MINNESOTA PLUMBING BOARD
ORDER DENYING VARIANCE

Re: Variance Petition
Oak-Land Middle School Additions Project
Lake Elmo, MN

To: Minnesota State Plumbing Board Date: December 10, 2024
From: Larson Engineering, Inc. Project No: 12246044
Project: Oak-Land Middle School Additions & Renovations
Re: Variance Regarding 2020 Minnesota Plumbing Code Section 310.5

C400

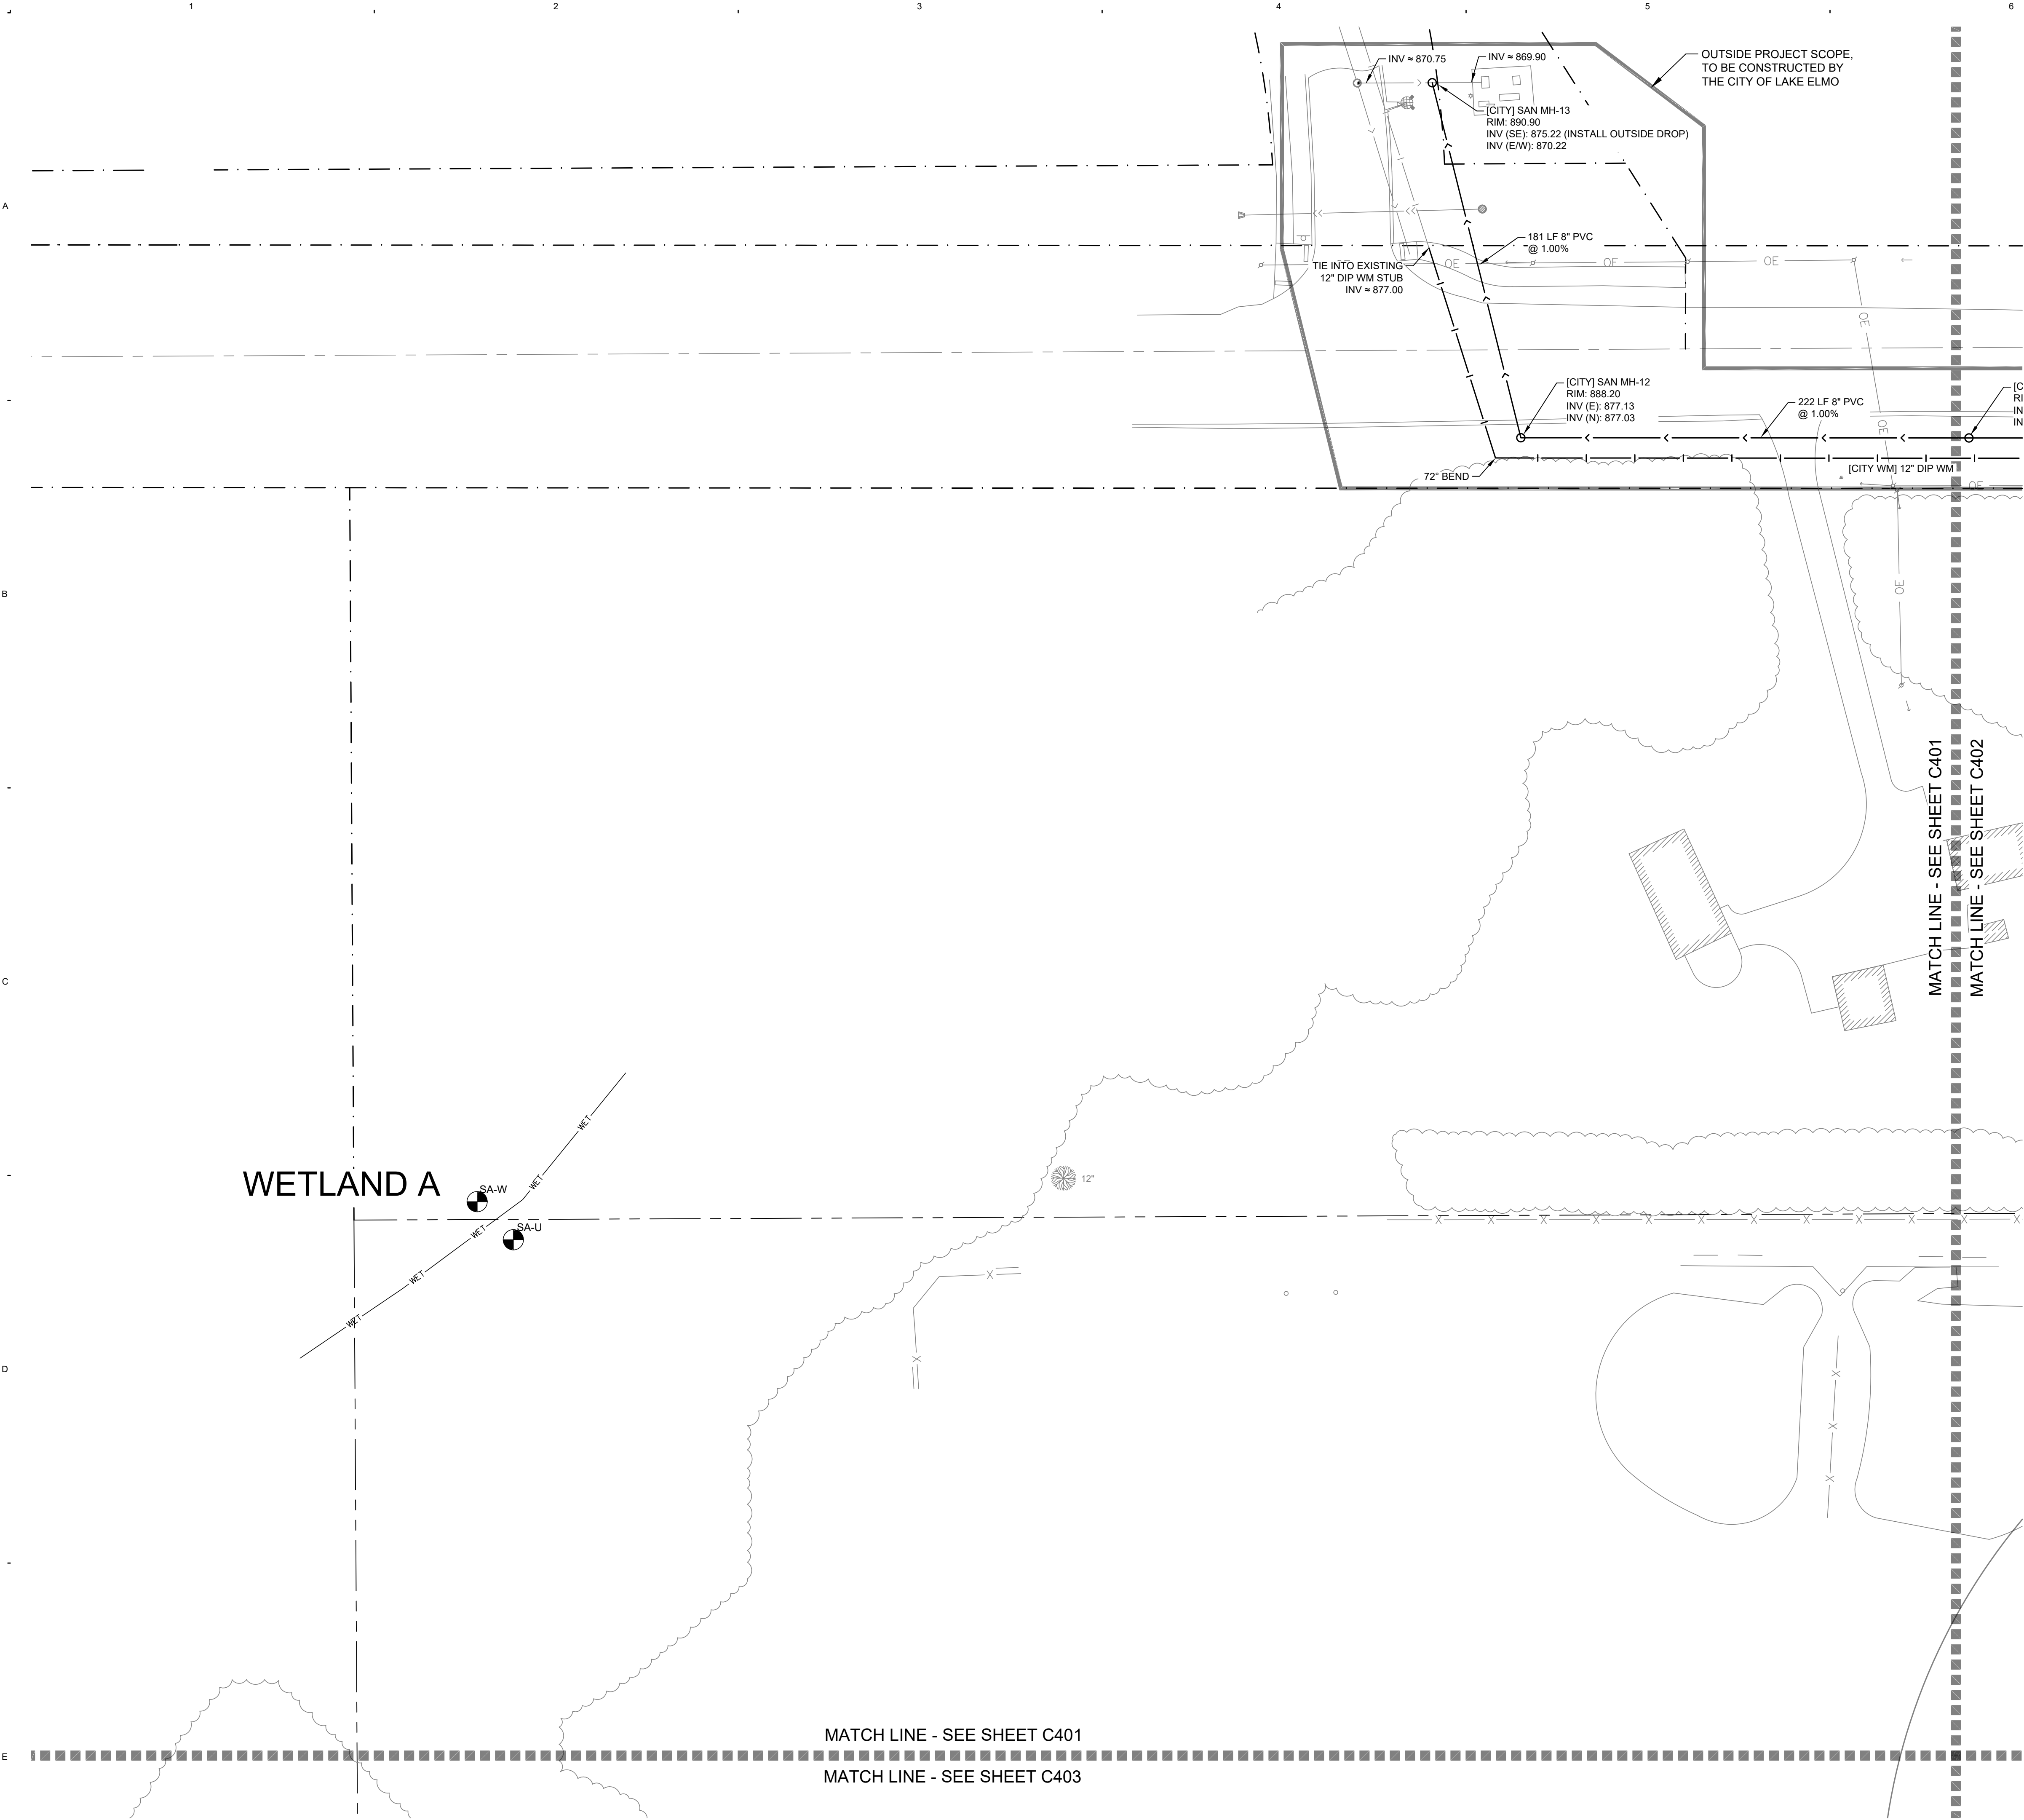
2. Provide a larger site plan showing elevations of the storm system, helps explain why you cannot connect to existing. Show other work that will be completed on the site. I have attached utility drawings to this email that depict the design if the drywells are maintained, but please note that the stormwater system for the site are rather complex and cluttered. This was initially withheld from the submittal to prevent confusion. The attached plan sheets are not the most recent utility plans for the project as the project is set to start construction this spring and we needed to proceed forward with an alternate design that included a lift station to service the existing roof leader which greatly increased the cost of the civil related work.

PROPOSED CONDITIONS IF VARAINCE IS APPROVED

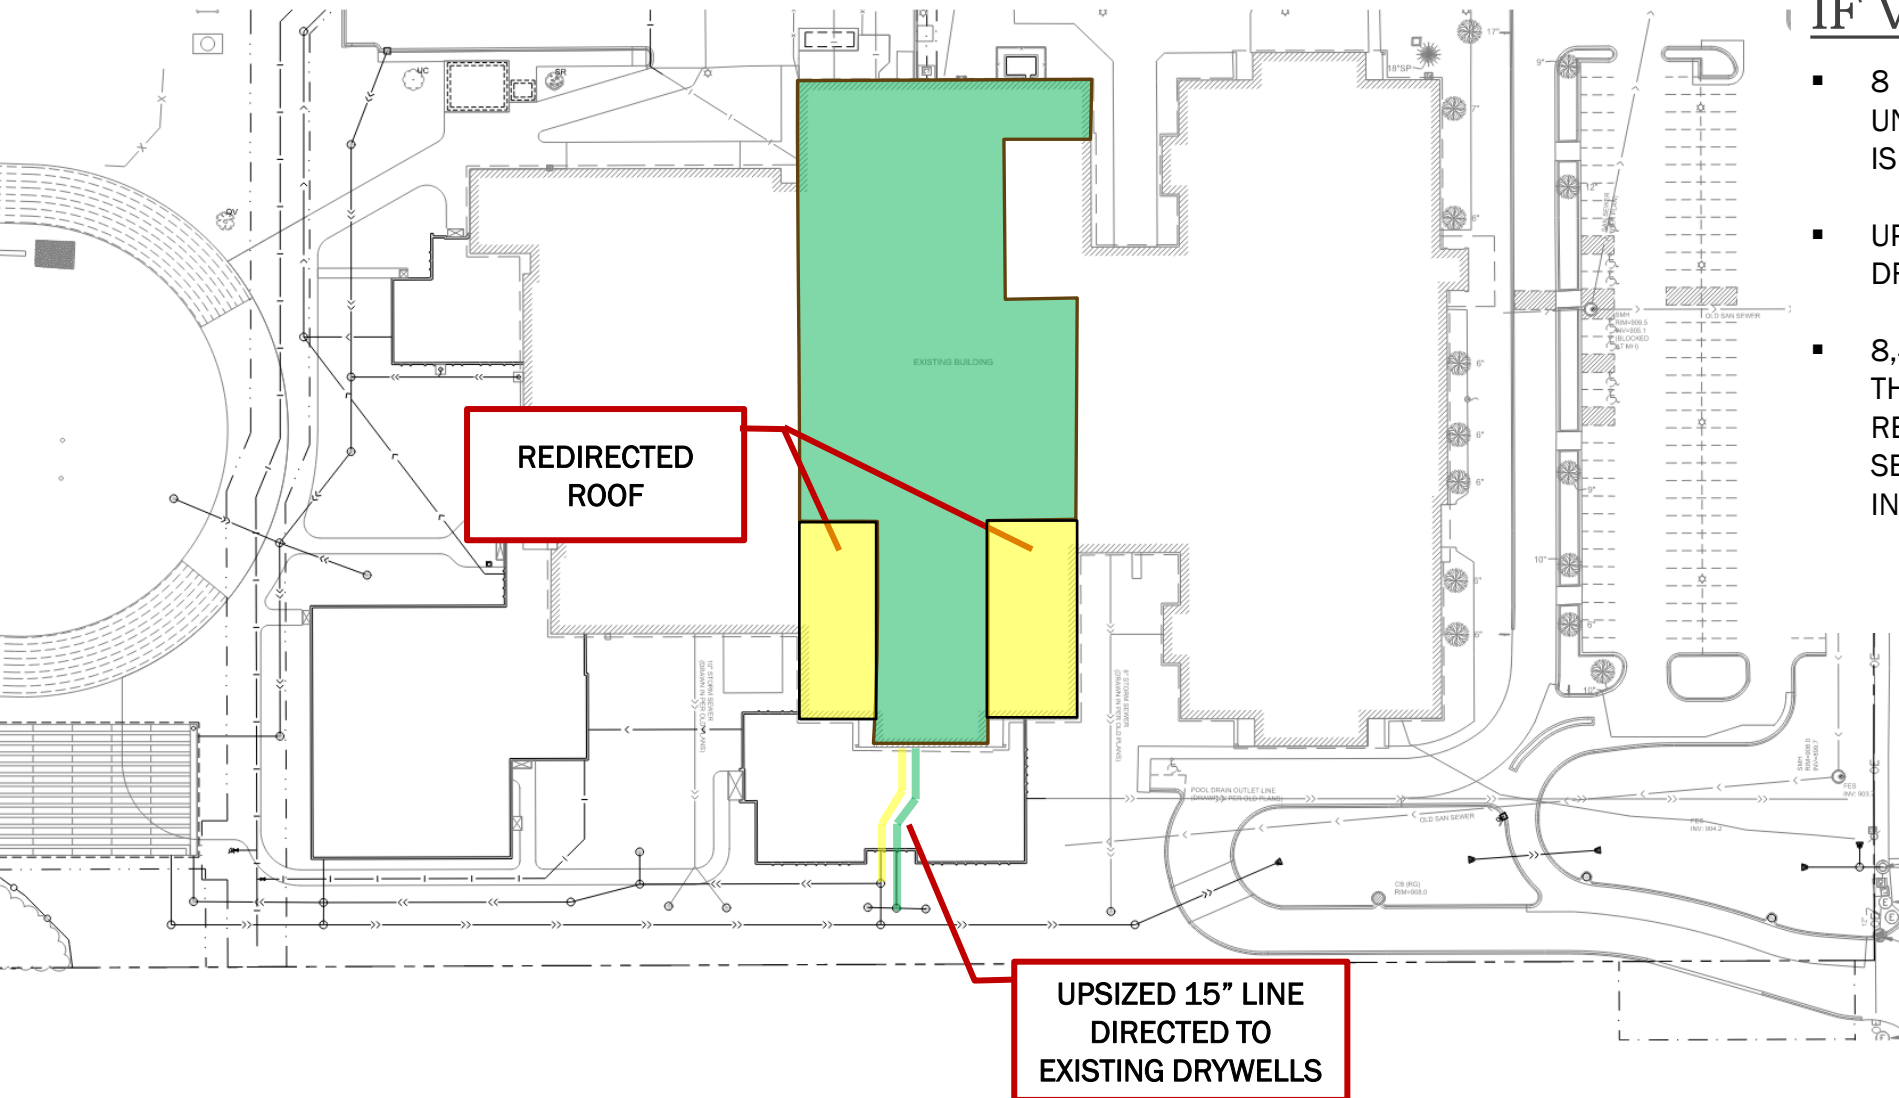
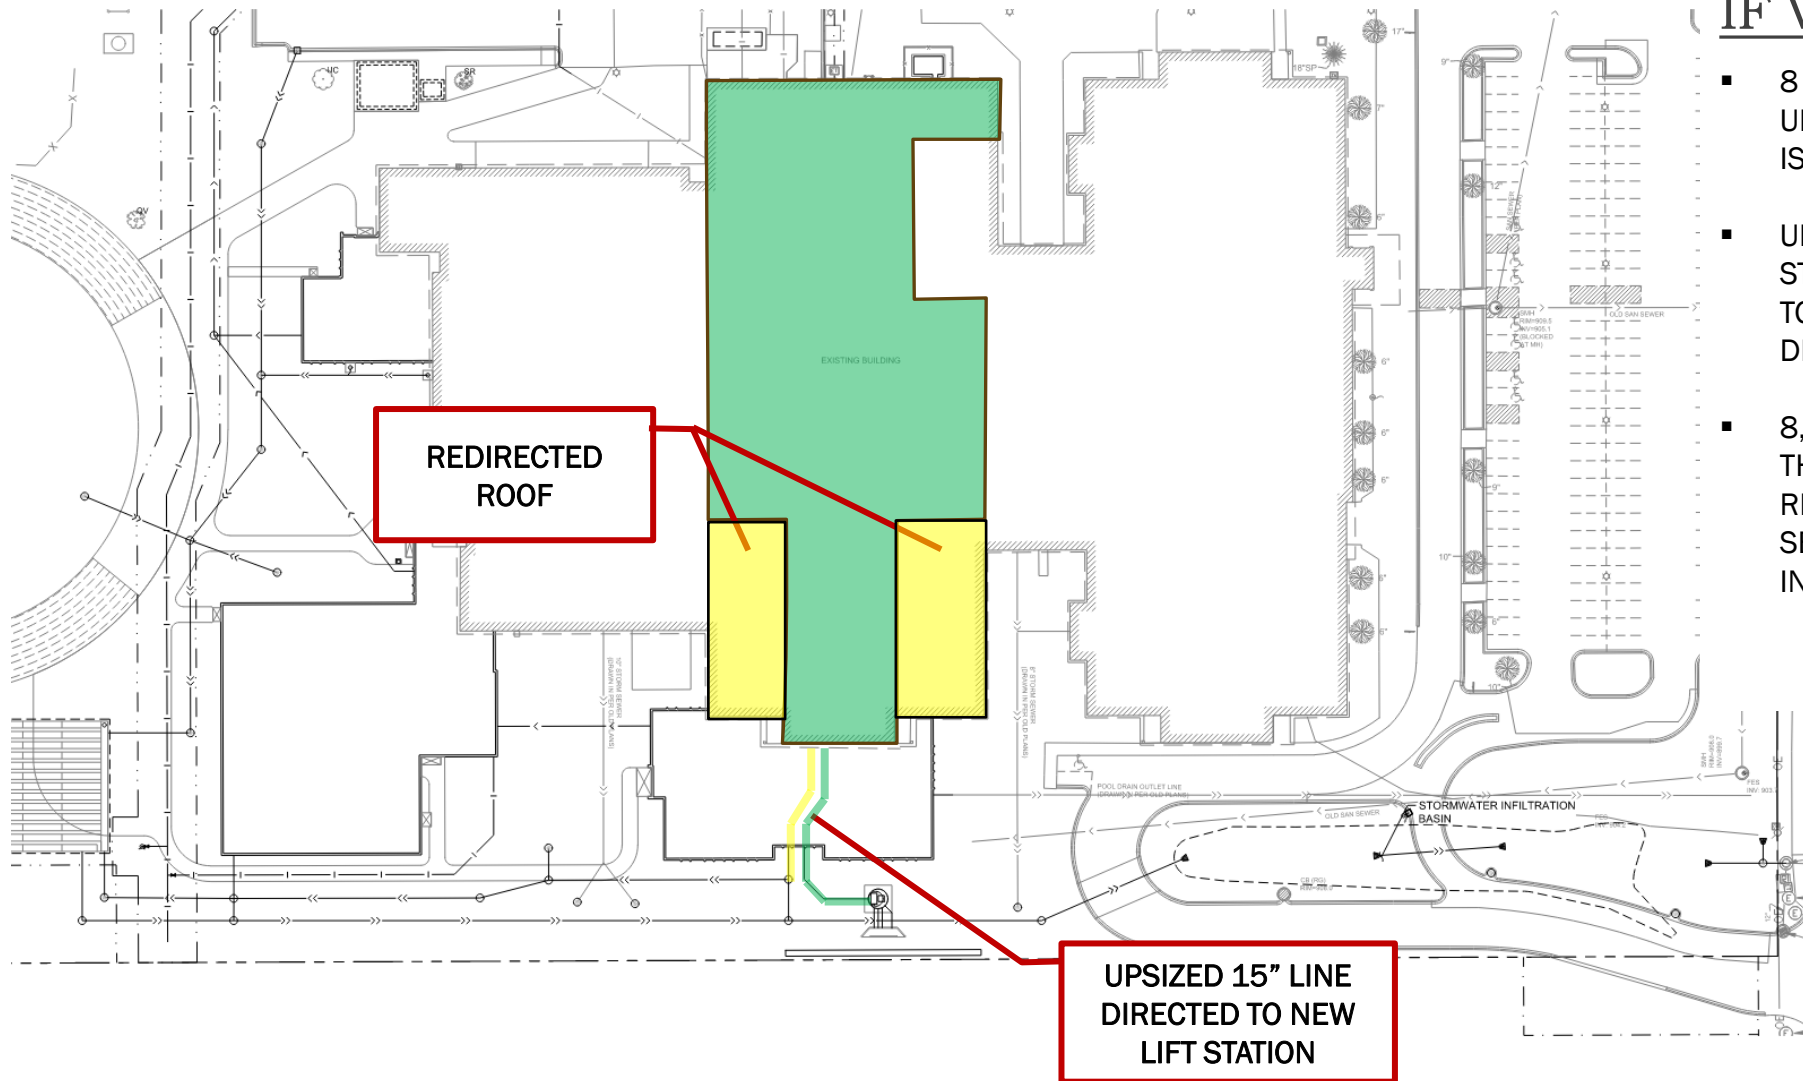
- 8 INCH VCP IS REVISED TO A 15 INCH PVC UNDER NEW ADDITION, DOWN STREAM PIPING IS ADJUSTED ACCORDNGLY
- UPSIZED PIPE CONNECTS BACK INTO EXISTING DRYWELLS
- 8,400 SF OF EXISTING ROOF THAT GOES TO THE EXISTING 8 INCH LINE WILL BE REDIRECTED TO A NEW ROOF LEADER SERVICED BY A NEW UNDERGROUND INFILTRATION SYSTEM.

- 8 INCH VCP IS REVISED TO A 15 INCH PVC UNDER NEW ADDITION, DOWN STREAM PIPING IS ADJUSTED ACCORDNGLY
- UPSIZED PIPE CONNECTS INTO A NEW LIFT STATION STRUCTURE DESIGNED TO BE ABLE TO PUMP 2,900 GALLONS PER MINUTE AND DISCHARGES ON GRADE.
- 8,400 SF OF EXISTING ROOF THAT GOES TO THE EXISTING 8 INCH LINE WILL BE REDIRECTED TO A NEW ROOF LEADER SERVICED BY A NEW UNDERGROUND INFILTRATION SYSTEM.
